42 HONEYSUCKLE DRIVE COTTAGE CREEK PRECINCT NEWCASTLE

NEWCASTLE CITY COUNCIL
DEVELOPMENT APPLICATION

ARCHITECTURAL DESIGN RESPONSES

MAY 2018
REV B

2.0 BUILT FORM BUILDING HEIGHT

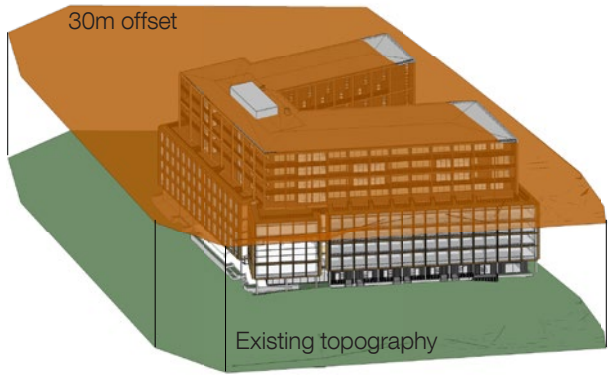
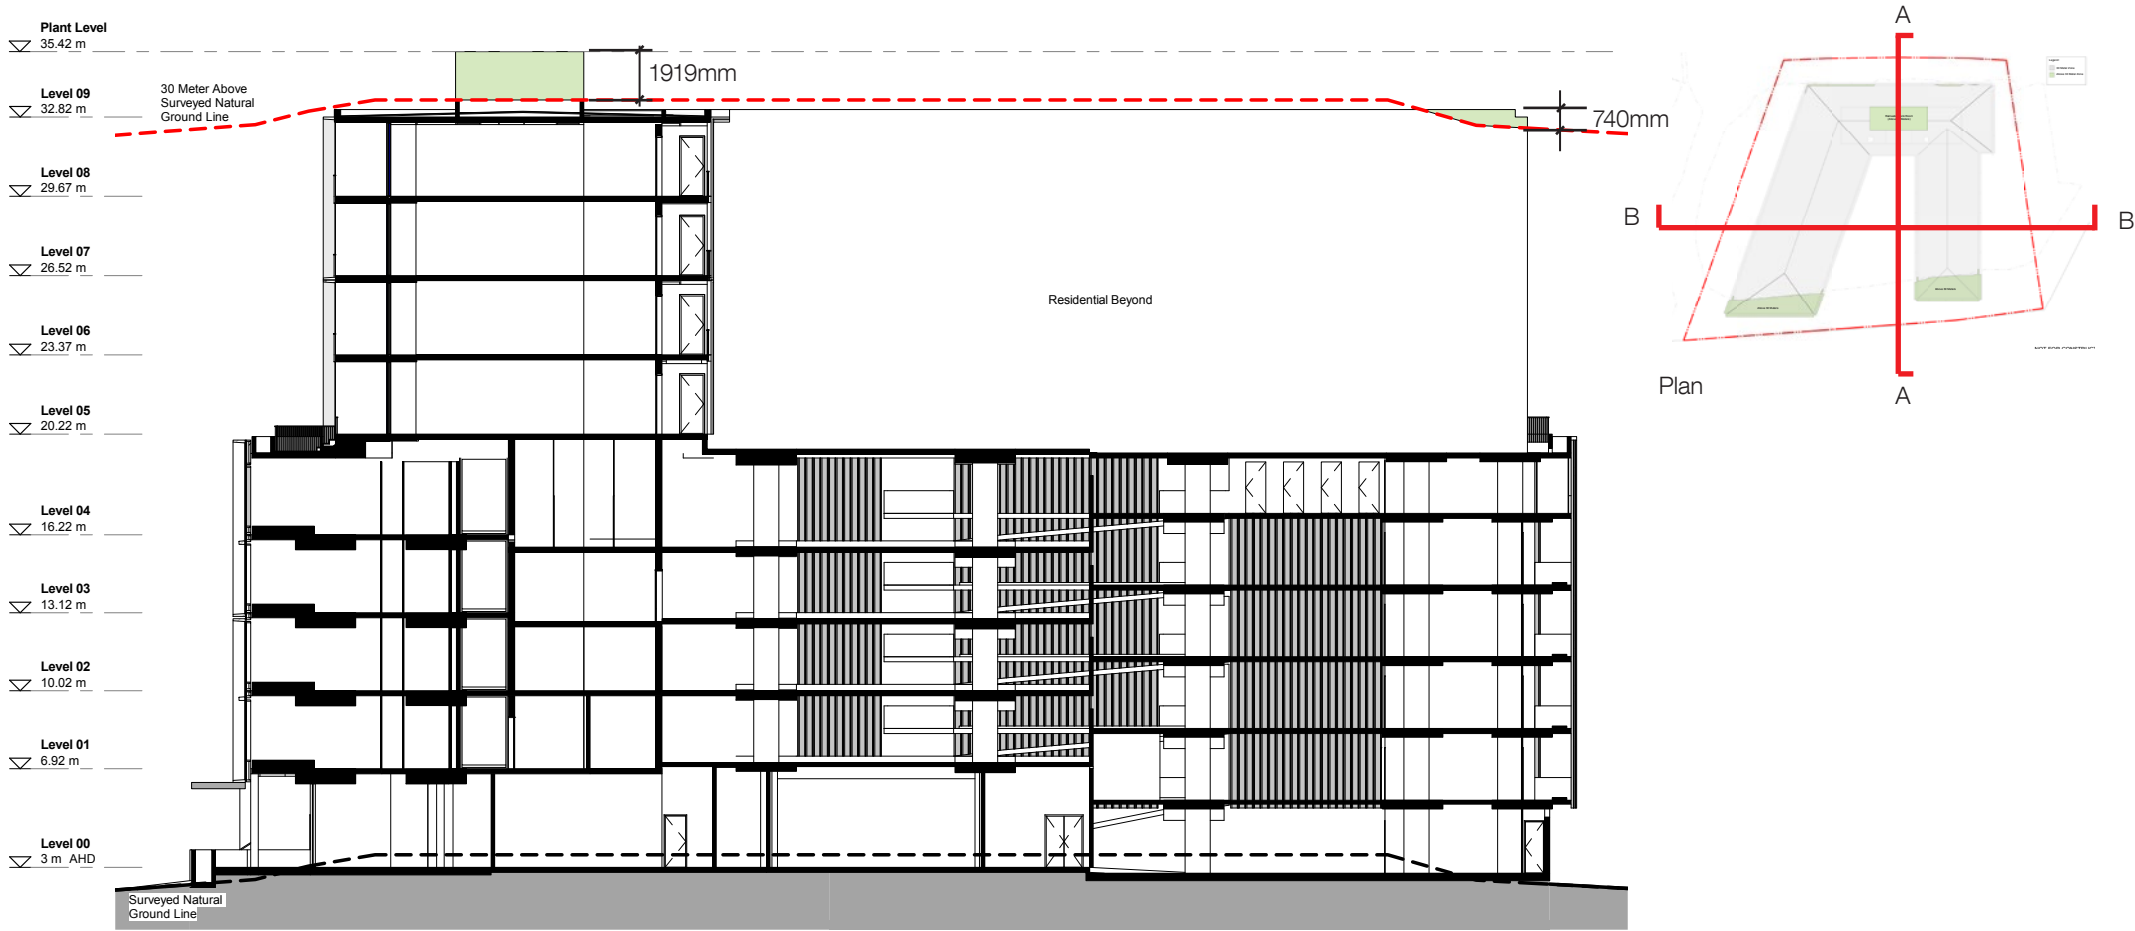
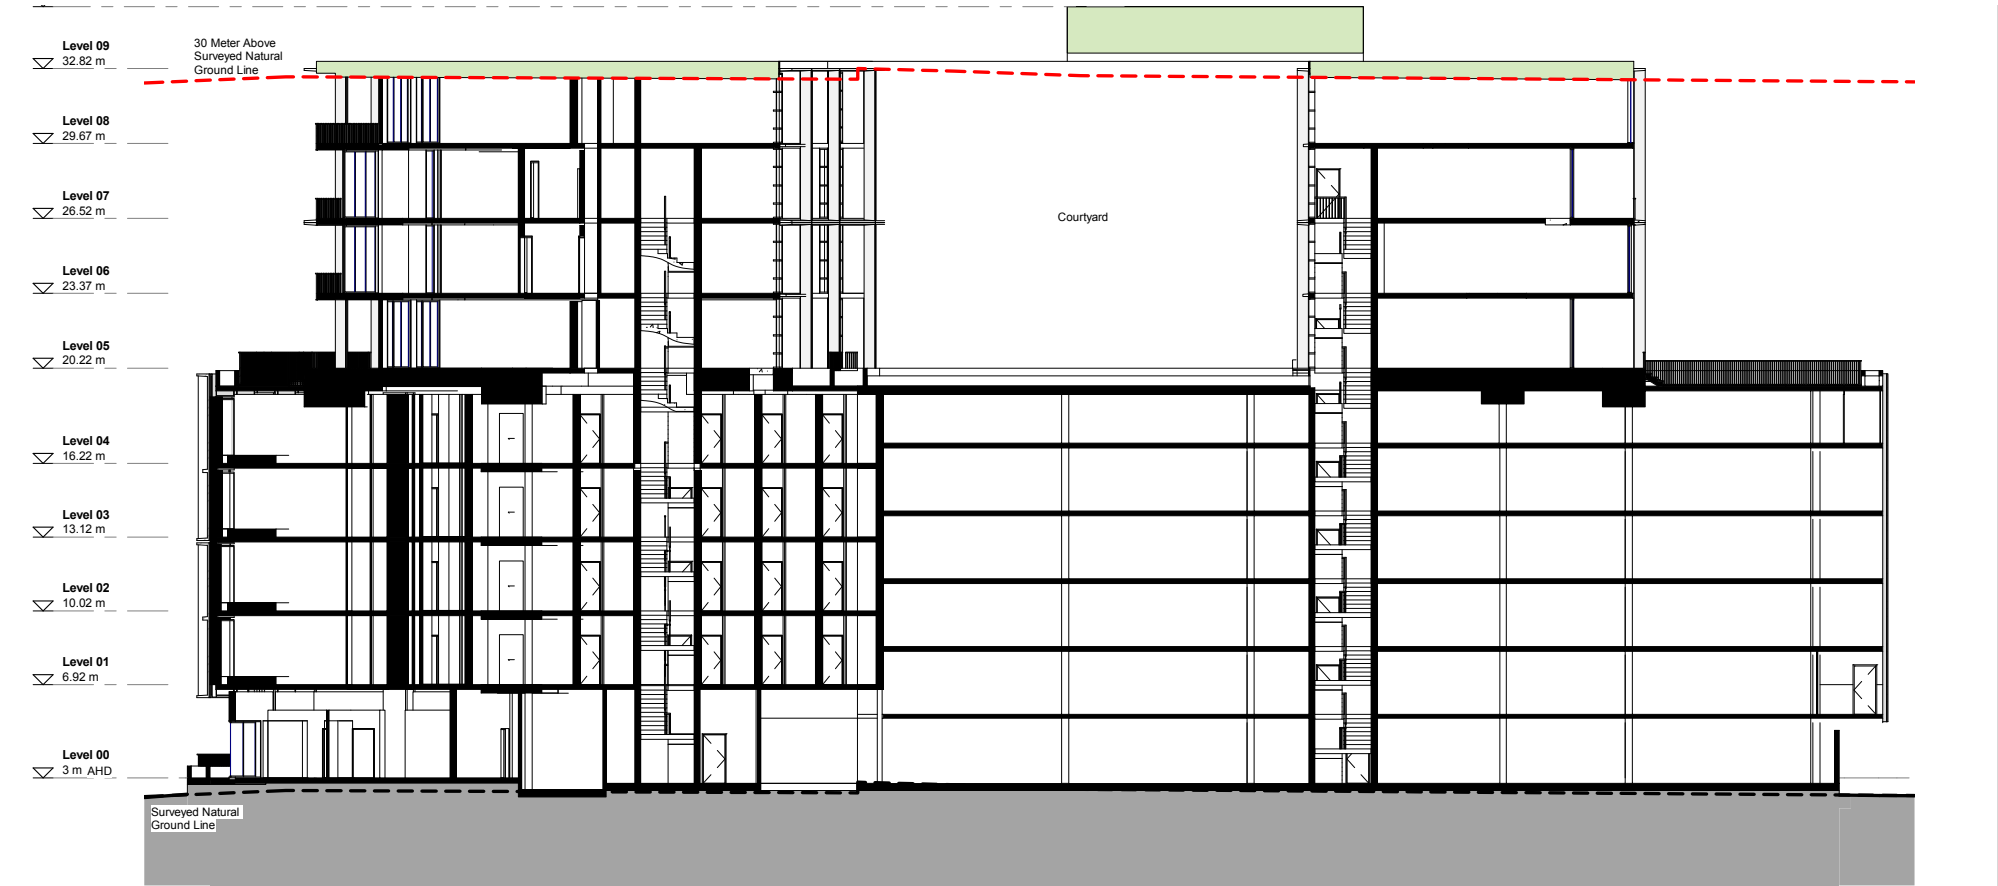
‘Provide further detail in plan and section form clearly identifying and quantifying the parts of the building which exceed the maximum height of 30 metres’

See plan, sections & 3D through the building illustrating the elements of the building that are beyond the maximum 30m height limit (highlighted in green). The red line demonstrates the 30m offset from the surveyed existing ground plane.

The green shading highlights clearly the portions of the building that are beyond the 30m height limit. These are the ends of the south roof to both east and west “wings” and the fire sprinkler tanks set in the middle of the plan to the northern roof.

2.1 BUILT FORM OVERSHADOWING

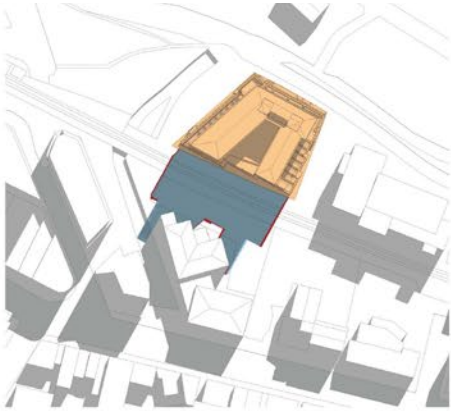
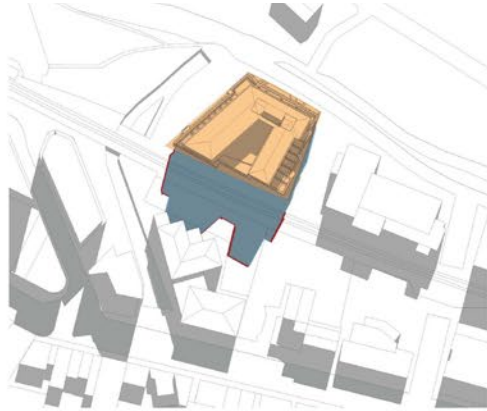
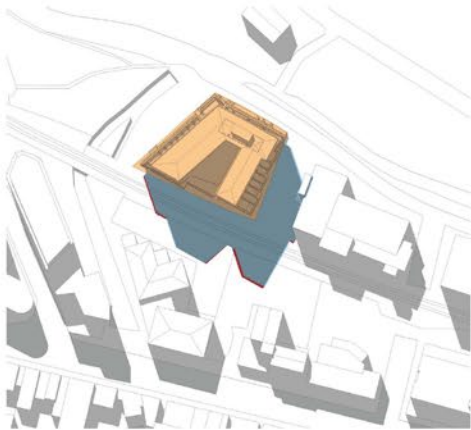
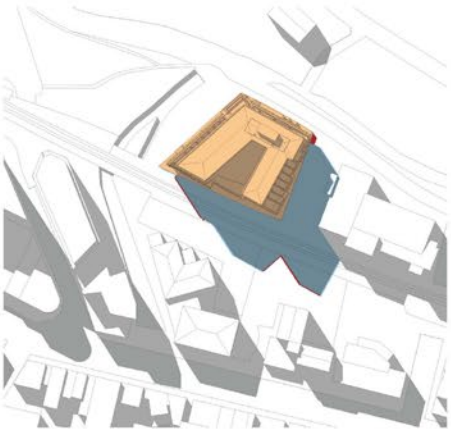
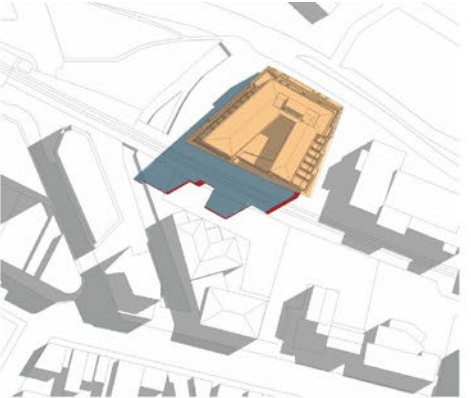
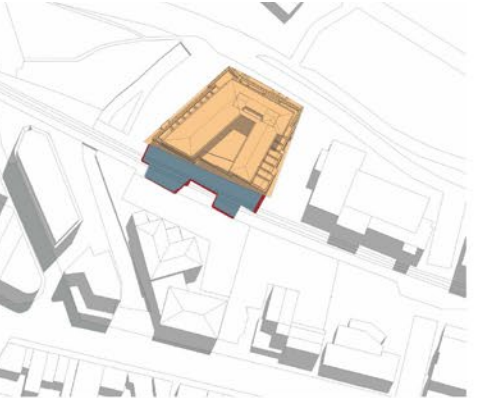
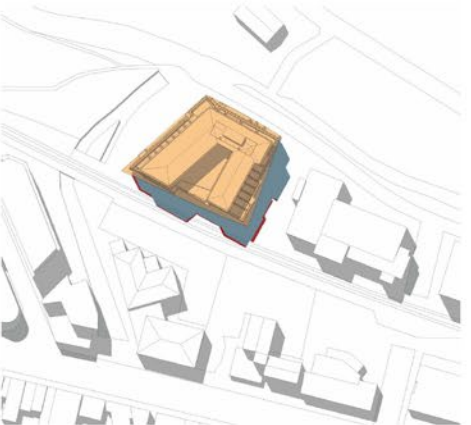
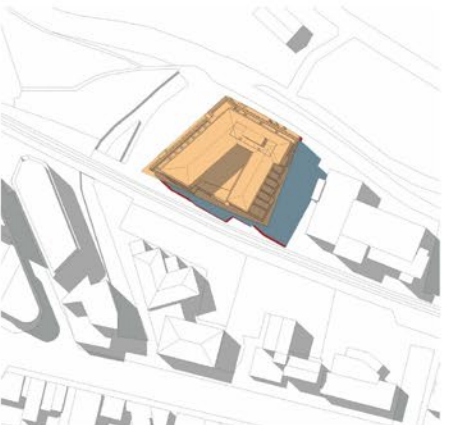
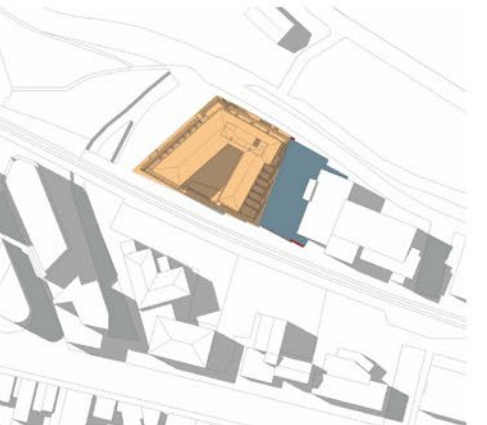
‘Provide revised overshadowing diagrams which clearly show a comparison between the proposed portions of the building which exceed the 30m height standard and a fully compliant building’

See the revised overshadowing diagrams illustrating the comparison between the 30m height standard and the current building form in both the winter solstice and the equinox.

It can be seen that the additional height has very little difference in the extended shadow due to the extra height being placed within the centre of the roof plan across the northern face. With varying permissible heights from neighbouring buildings ensures that the building maintains a presence and prominent address without affecting greatly the green belt and pedestrian connection from the light rail to the waterfront.

View Locations

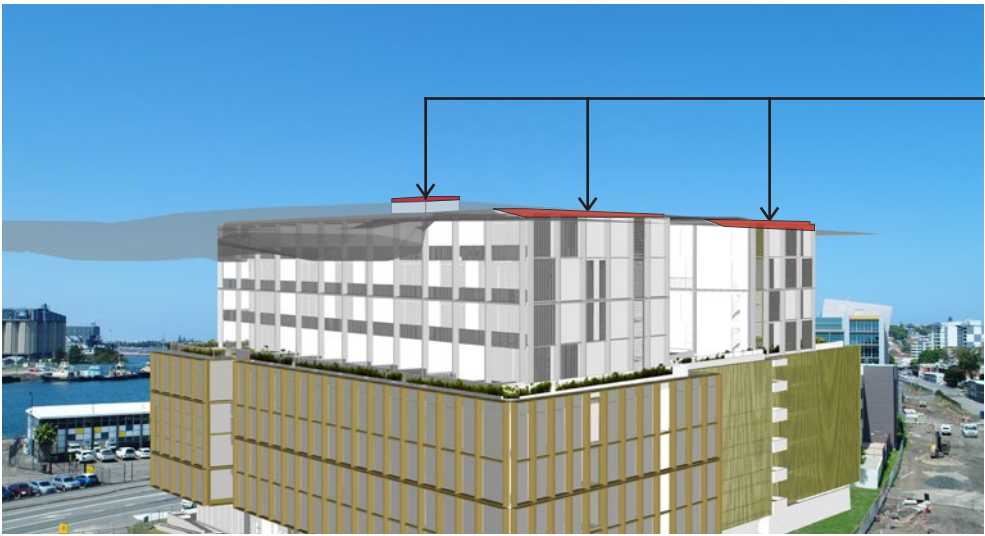
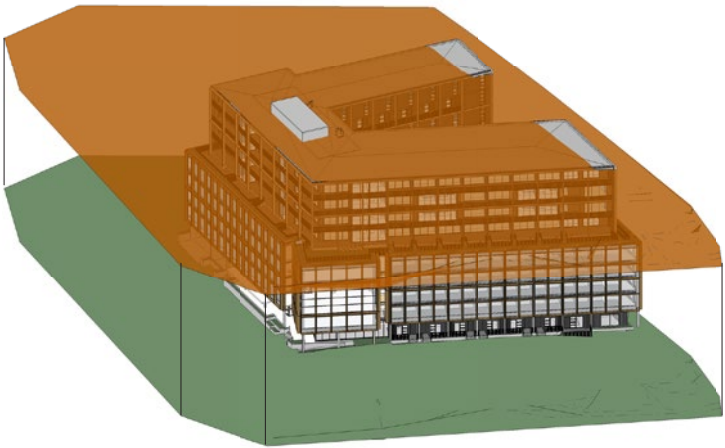
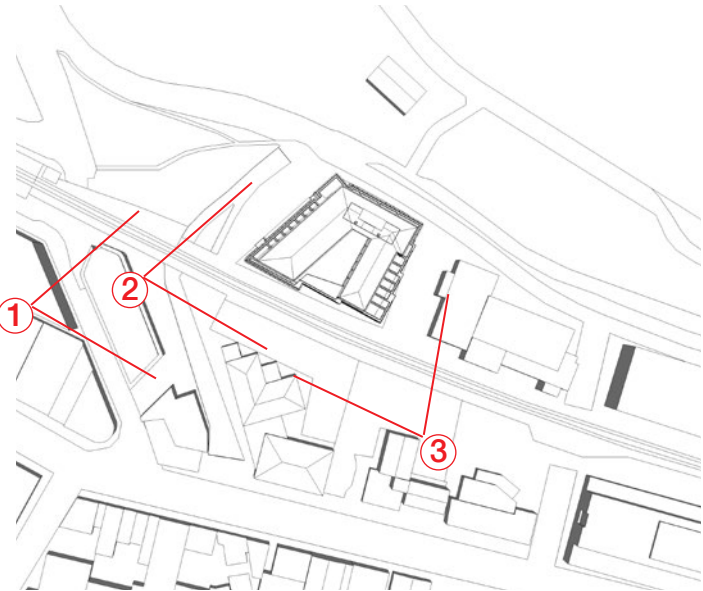
‘Provide an analysis of view impacts associated with the proposed variation to the 30m height standard on existing nearby residents, noting the concerns raised about view loss in public submissions’

These controls have informed the building design for 42 Honeysuckle Drive and the majority of the building sits well within the 30m height limit, which is entirely in-keeping with the surrounding development profile. The elements that project beyond the 30m are the roof top plant and the eaves to the southern roofs of the east and west “wings”.

View 1. **Astra Apartments**
New development 8 storey's high + ground
South - West View
Top floor apartment at approximate 27 meter AHD
View significantly zoom in to illustrate the building edge above 30m - no view of the plant room to the north

View 2. **25 Bellevue St**
Development 8 storey's high + ground
South - West View,
Top floor apartment at approximate 27 meter AHD
View significantly zoom in to illustrate the building edge above 30m - no view of the plant room to the north

View 3. **Ibis Newcastle Hotel**
3 storeys high + ground
South - East View,
Top floor hotel room - approximate 15 meter AHD
View significantly zoom in to illustrate the building edge above 30m - little view of the plant room and the southern building edges

2.3 BUILT FORM:

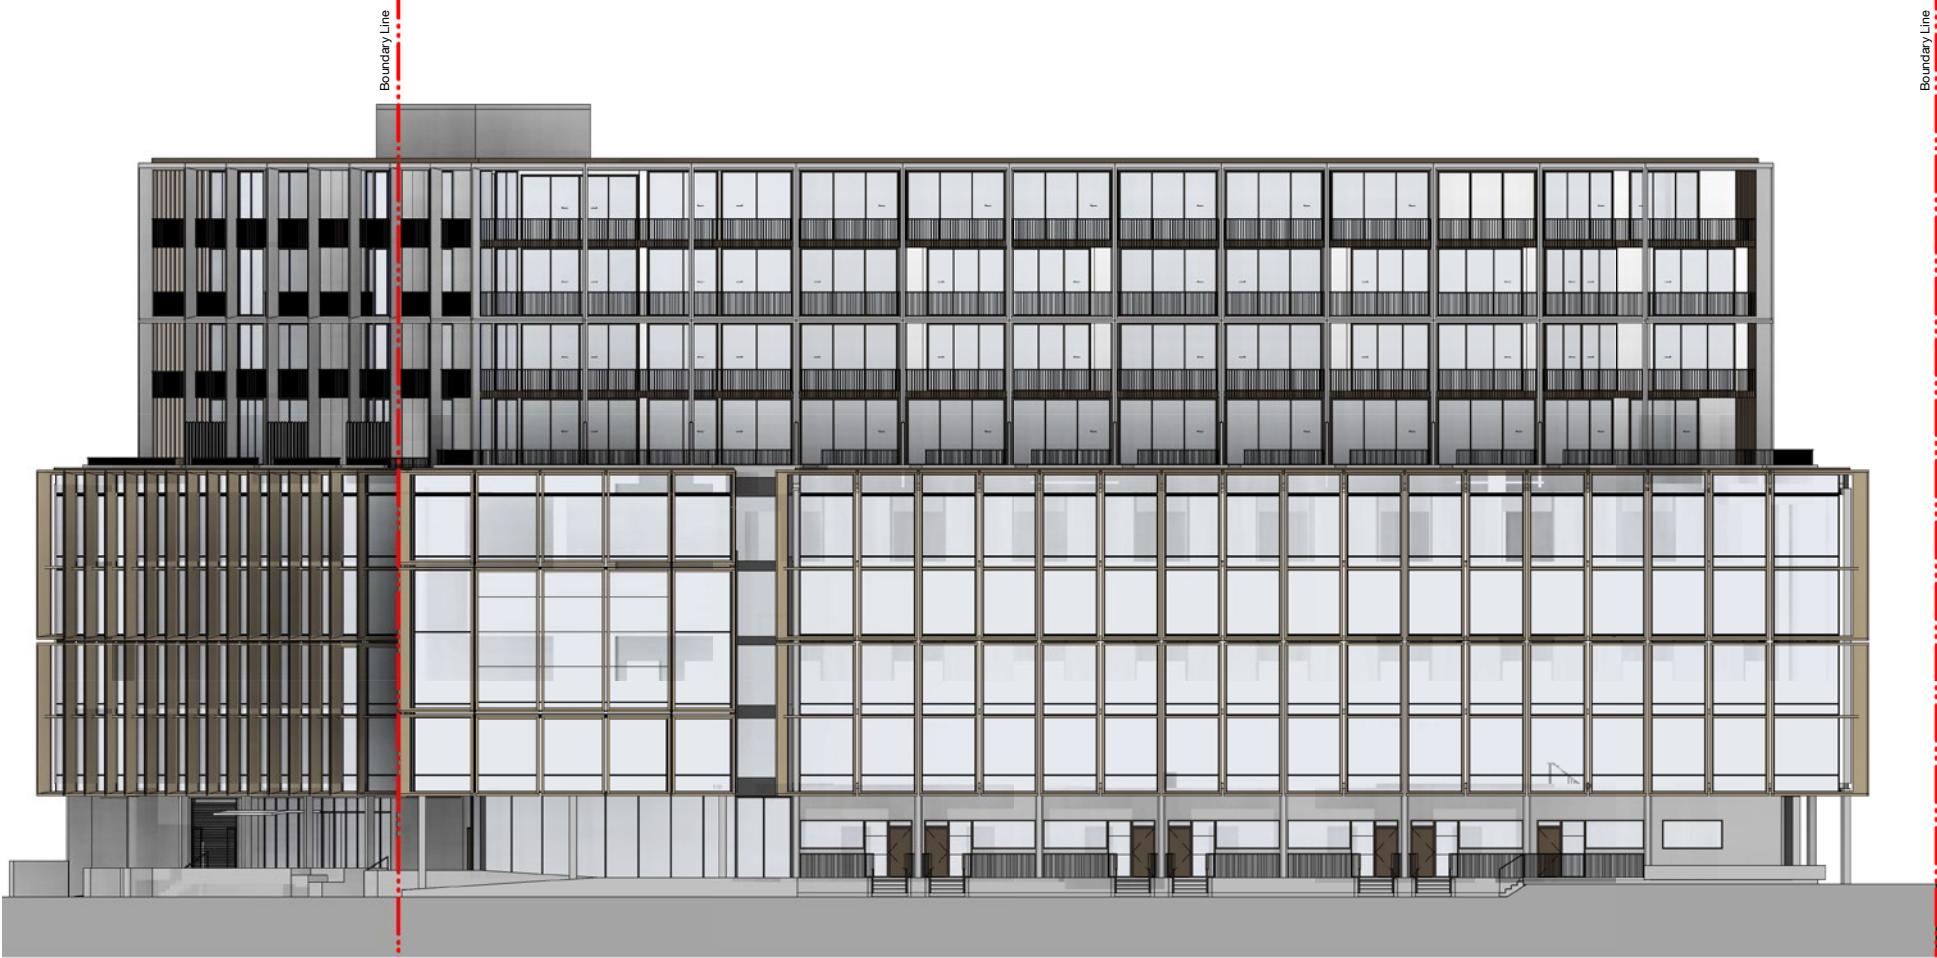
The proponent should propose strategies for screening private external drying areas and storage zones from the public domain. Alternative communal facilities could also be considered including communal drying areas or drying rooms'

We understand the importance of hiding personal items on balconies. Making the balustrade 2/3 solid is one way of addressing the issue but this should not drive the architecture and facade design.

Our suggestion would be to avoid having a 2/3 solid screening to the external drying areas as all apartments will want to maximise their waterfront views.

The apartment layout will provide a separate integrated laundry and each apartment will be supplied with a drier. Moreover, byelaws will be written into the strata to eliminate any drying on balconies to avoid the risk of clothes being blown over the balustrade and across the street.

The building base has been carefully articulated to provide appropriate scale, relationship and interest to the public domain. At level L05, the building form is set back relative to the Hotel component below, creating a landscape zone bordering the generous residential balconies to further break down the scale of the building and step back within the overall footprint. This should result in further obscuring the views from street level.
